Project Name: POCO #67
OCCC Campus Lighting Relay Control & Cabnt Replacement

Project Number: Y22-7039

**ORANGE COUNTY CONVENTION CENTER
CAPITAL PLANNING
SCHEDULE A: POTENTIAL CHANGE ORDER (PCO) COVER PAGE FOR PRIME CONTRACTOR**

PCO No. 67 **PROJECT:** OCCC Campus Lighting Relay Ctrl & Cabnt Repl **DATE:** 09/24/24

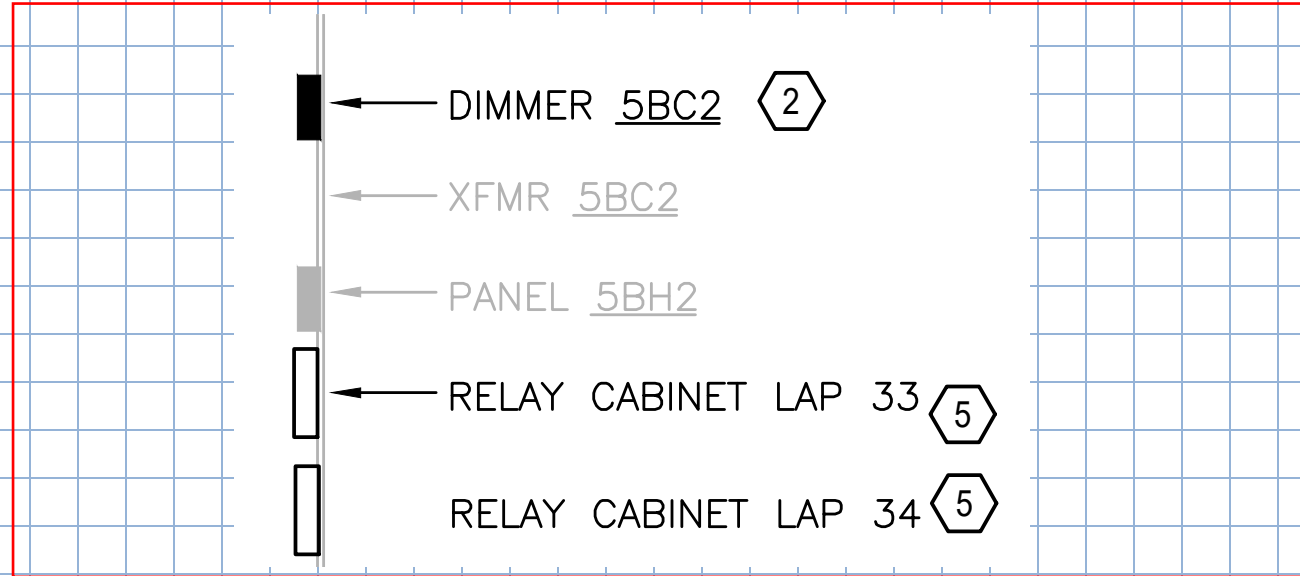
Question:
Per West_Drawings_VOL_4 E706, West Bldg., 4th Level, Area: ED2429, Room: HALL B4 S CAT, Panel: 5BC2 a (1) SR12 with 18 dimmers and 6 non-dims. was allotted for the scope of work. After surveying the area is was noted that it actually requires (1) Aux Bay, (1) SR48 dimmer rack with 40 dimmers/non-dims. This requires a change order.

Per West Drawings VOL 4 E706, West Bldg., 4th Level, Area: ED2429, Room: HALL B4 S CAT, Panel: 5BC2 a (1) SR12 with 18 dimmers and 6 non-dims. was allotted for the scope of work. After surveying the area it was noted that it actually requires (1) Aux Bay, (1) SR48 dimmer rack with 40 dimmers/non-dims. This requires a change order.

Originally Quoted: (1) SR12 with 18 dimmers and 6 non-dims.

Response:
Dimming panel schedule sheet E706 show a quantity's of 49 dimming circuits . Per specifications section 260500 1.7 A Candela Controls requested additional site visit in addendum 3 to verify power feed requirements. specification section 260943 2.7,B,9 rack enclosures shall be designed for use with auxiliary racks for main circuit breaker. Work shall be done at no cost to the owner.
